PRELIMINARY/FINAL DRAINAGE REPORT

JUDGE ORR ROAD RV PARK & STORAGE DEVELOPMENT

**ADP Project No.160301
November 6, 2018**

PCD Project #PPR-16-040

PROJECT MANAGER: HUG
CAD FILE NO.: 160301-Developed Conditions
JOB NO.: 160301
SCALE: 1" = 100'

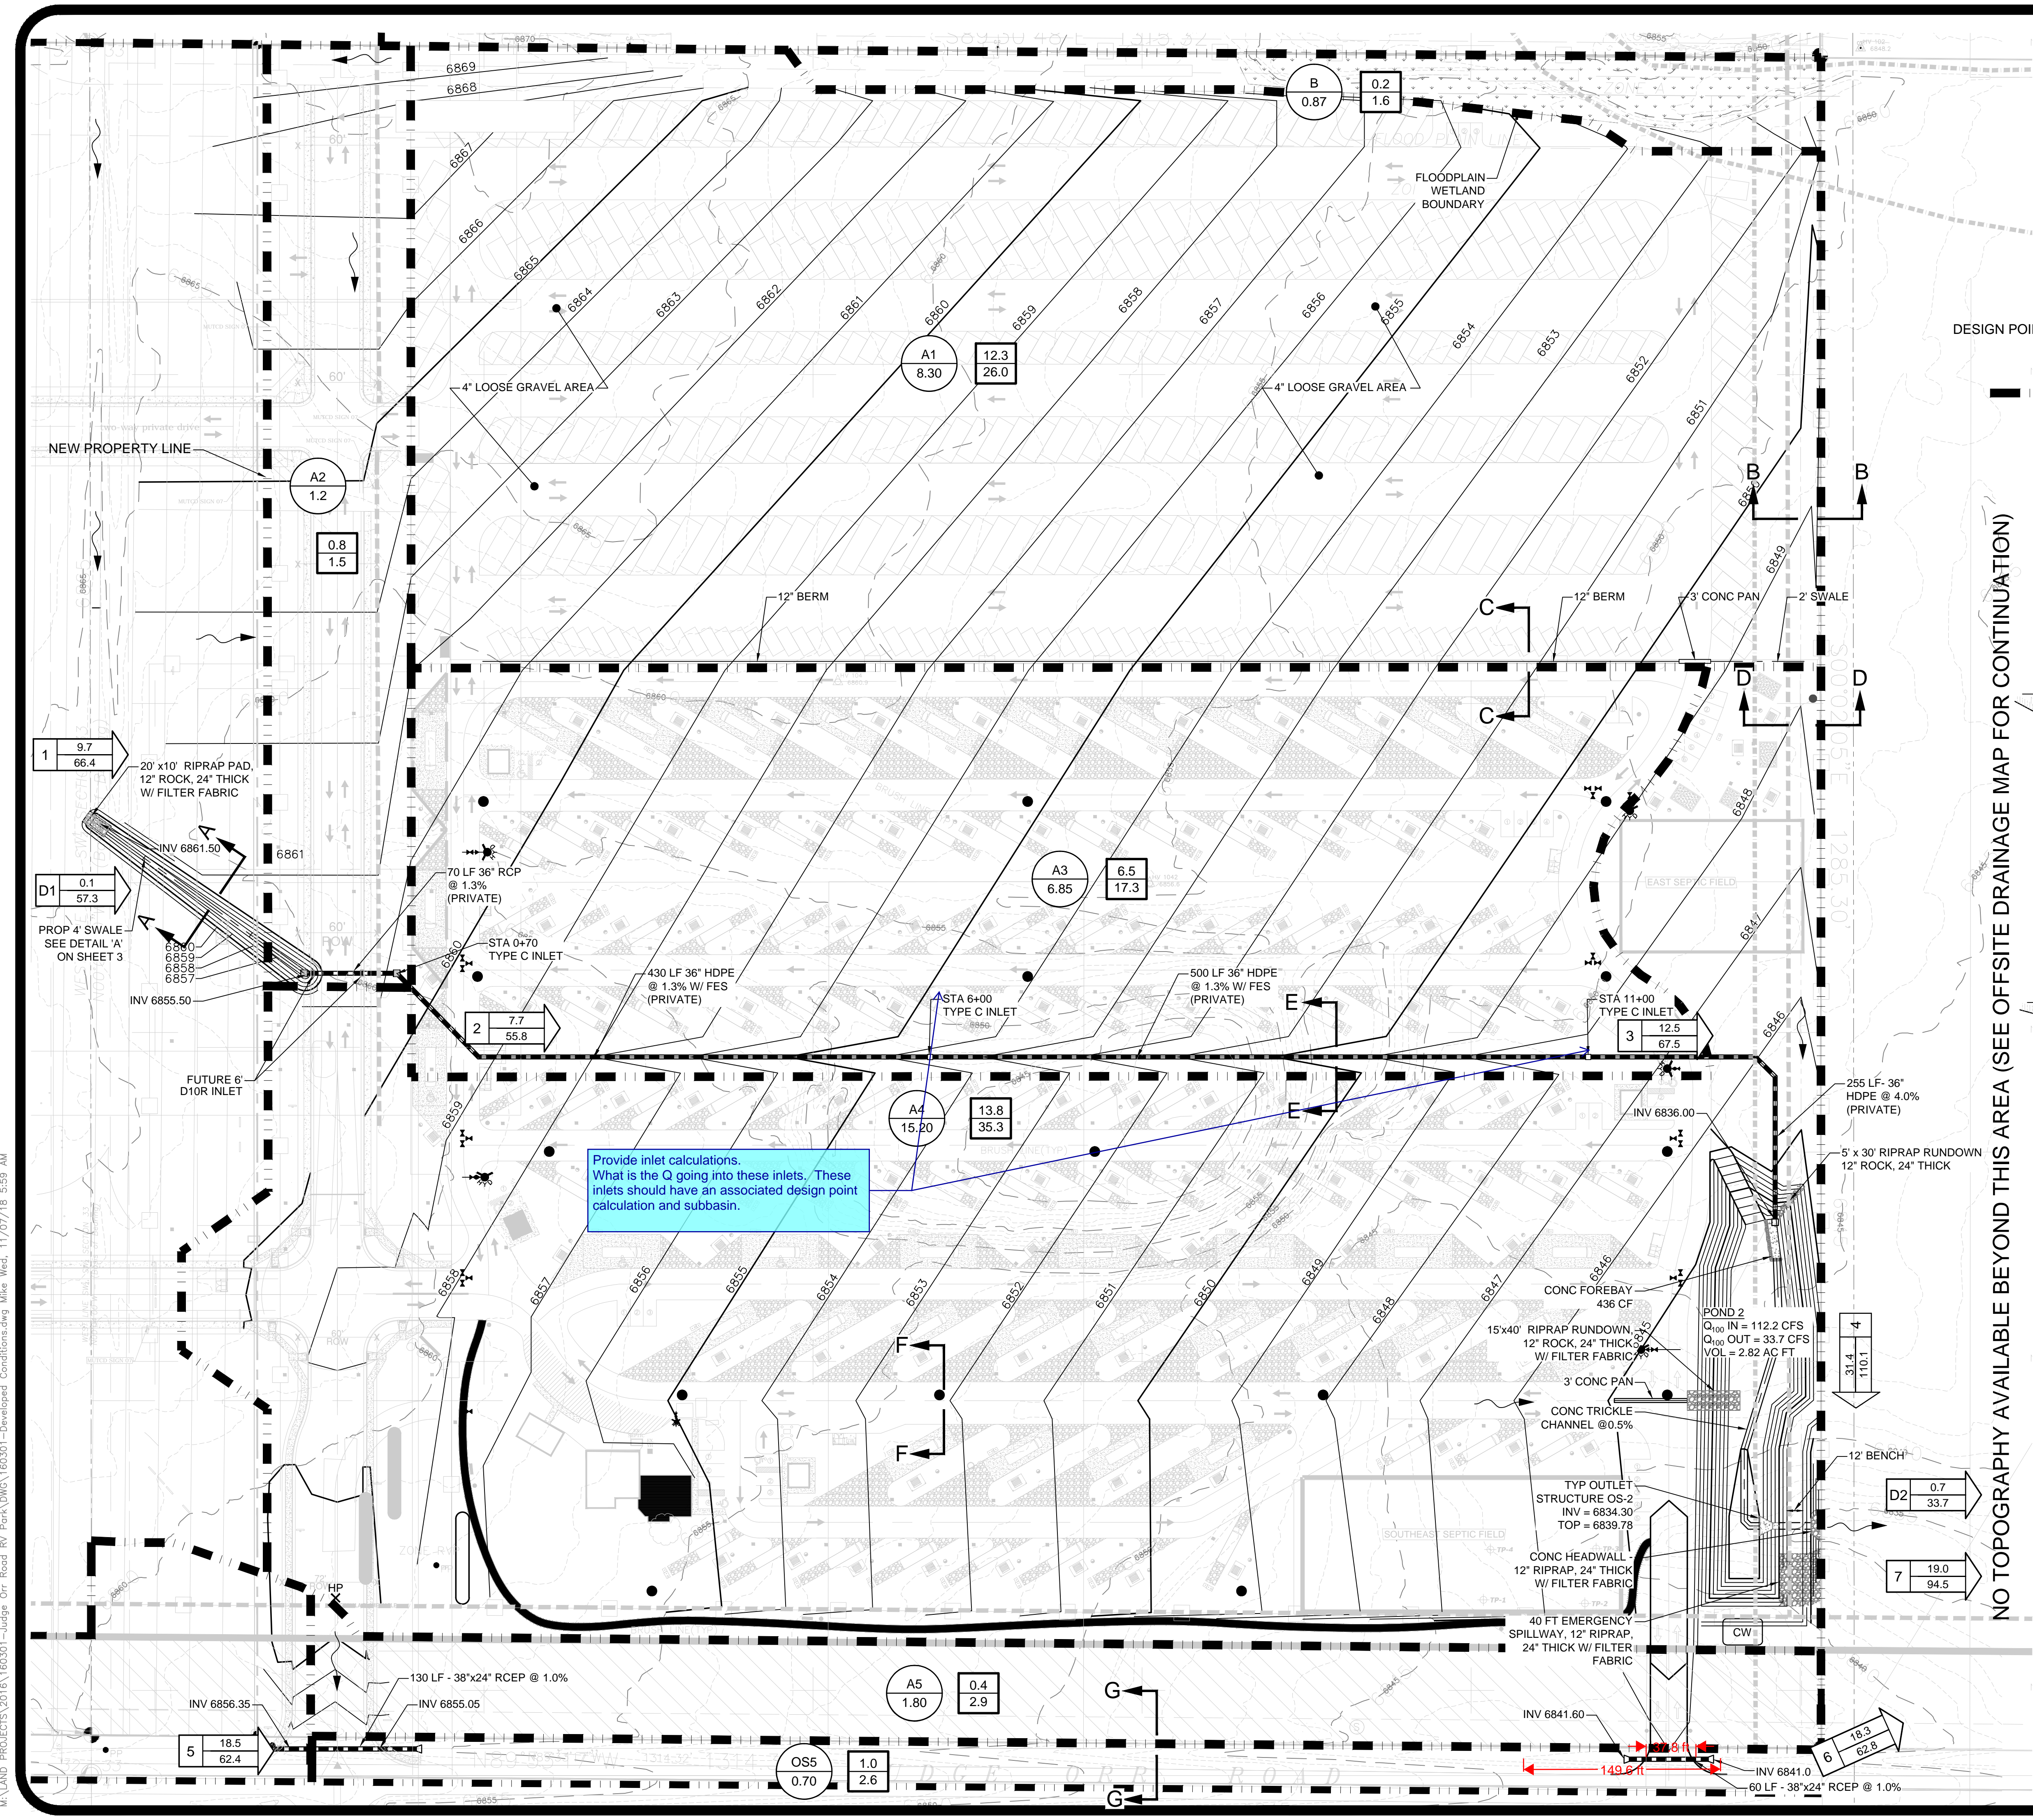
In the developed condition (pg 4) it noted off-site area remains the same. The design engineer noted on the 8/8/18 meeting that the intent was to pipe OS3 through basin OS2 and discharge to the Judge Orr ditch and not flow within the revised OS2 basin boundary shown on the proposed drainage map.

Update the narrative to discuss and provide analysis for the diversion. Is the ditch still hydraulically adequate with the reroute?

Provide analysis and narrative regarding emergency spillway when Pond 1 is constructed. Based on current design, it appears that the emergency spillway path will be diverted south and into the existing ditch along Judge Orr road. What impact will this have.

1. Extend the drainage map to show the location of DP7

Callout the specific product to be used and in the appendix include the product specification that shows it is designed to handle the specific Froude number calculated.
Typ. all

Provide inlet calculations. What is the Q going into these inlets. These inlets should have an associated design point calculation and subbasin.
